#### TOWN OF MONTVILLE

# Department of Land Use & Development

Application: **24SITE12**

**Proposal:** Change of use from single family residence to business/professional office to be used by the Language Department of the Mohegan Tribe of Indians of Connecticut which may also hold small weekly Mohegan immersion classes for Mohegan families. The applicant states there are currently 5 full-time on-site employees in the department who usually work Monday through Friday from 8:30 to 4:30 with an occasional weeknight or weekend day language class. The classes would likely have five to ten participants.

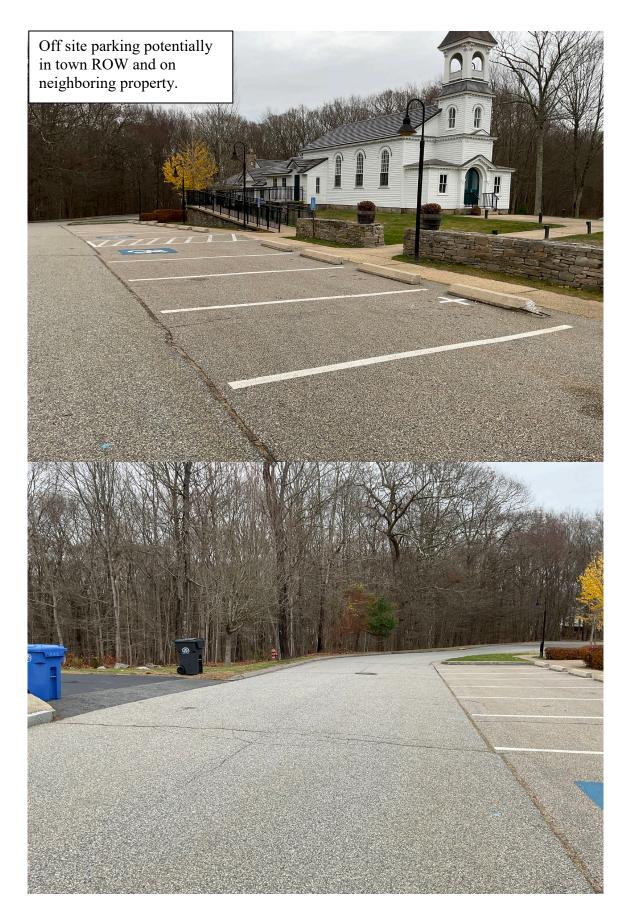
- 5. Clarify how trash removal will be handled as no dumpster is indicated on the site plan.
- 6. Show any off site parking that requires the use of access drive. See last picture for further explanation.
